City of Melbourne submission to the West Gate Tunnel Project

4 July 2017

CITY OF MELBOURNE DRAFT SUBMISSION WEST GATE TUNNEL PROJECT

Figure 2: Footscray Road, Dynon Road and Wurundjeri Way extension **Source:** Figure 5-12 of the EES.

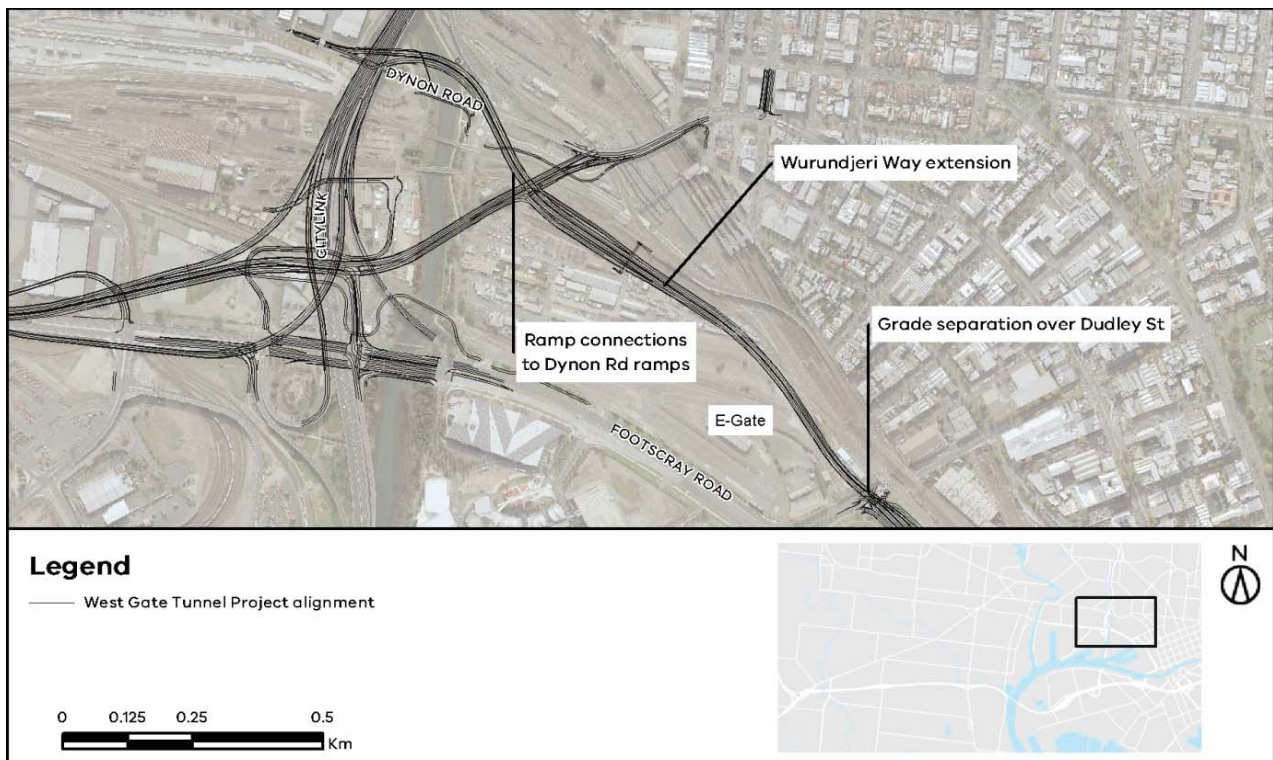
The City of Melbourne opposes the Project’s connection to Dynon Road. The Dynon Road connection has limited strategic rationale, particularly in relation to the Project’s objectives. It will introduce significant amounts of traffic onto local streets in North Melbourne and beyond, which will undermine the operation of key economic precincts such as the biomedical precinct and the innovation district as well as existing public transport. This section of the Project is in conflict with City of Melbourne policy and undermines decades of work to reduce through traffic in this precinct. The City of Melbourne does not consider that the impacts of this connection can be managed or mitigated; and therefore submits that the connection should not be constructed as part of the Project.

Figure 4: Cross section of the Footscray Road Elevated Structure Source: EES Map Book

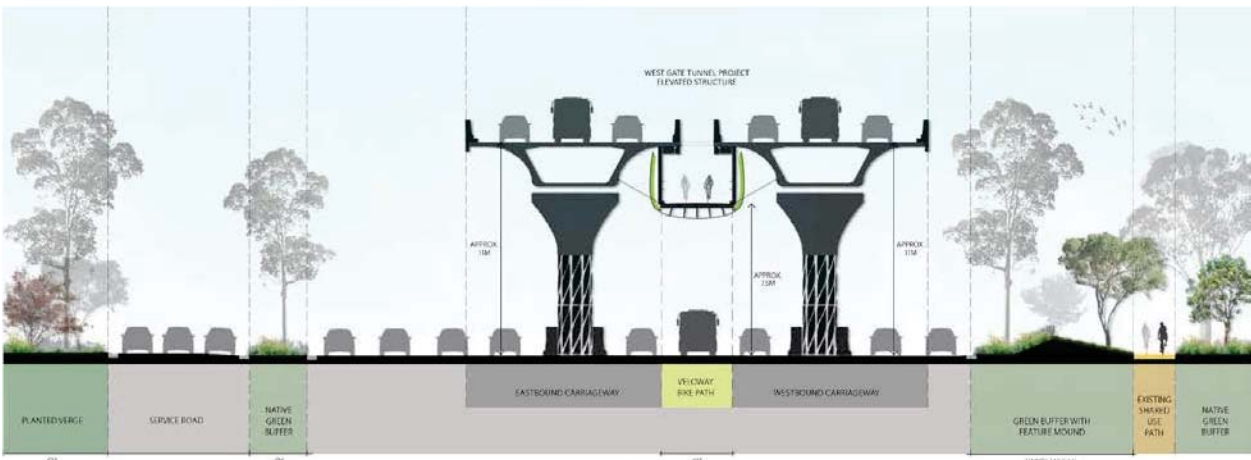
The City of Melbourne is opposed to the elevated structure along Footscray Road.

Landscape and Visual Impact	<p>7. Landscape and visual impact of the elevated roadway structure on Footscray Road and surrounds has not been adequately assessed.</p> <p>8. The impact on the realisation of Footscray Road as a boulevard, as identified in the Melbourne Planning Scheme, has not been adequately assessed.</p> <p>9. Mitigation strategies proposed for acknowledged landscape and visual impacts as a result of the Footscray Road elevated structure are not adequate.</p>
Urban Forest	<p>10. The impacts on the urban forest, including its amenity, landscape and ecology, as a result of the loss of approximately 537 trees along the Footscray Road corridor have not been adequately assessed or mitigated.</p> <p>11. The impact of the Project on growing conditions along Footscray Road has not been adequately assessed.</p>
Open Space	<p>12. The impacts on open space, including the value, quality and amenity of existing and new areas of open space to be introduced in the precinct, as a result of the Footscray Road elevated roadway have not been adequately assessed.</p>

Failing this, the City of Melbourne considers that the Footscray Road section should be redesigned with an associated rationalisation of the existing road conditions along Footscray Road. This would have a reduced negative impact on urban renewal and built form outcomes along this corridor as well as future permeability. It would also provide enhanced opportunities for open space and landscaping and the provision of public and active transport.

If the Project is to proceed as an elevated structure, the elevated structure should be redesigned to mitigate the impacts of the design. This includes improving the ability for ground level amenity and functionality – the current height of the structure doesn't provide for this to occur, the rationalisation of traffic lanes at surface and the relocation and redesign of the veloway (see further discussion at section 4.6).
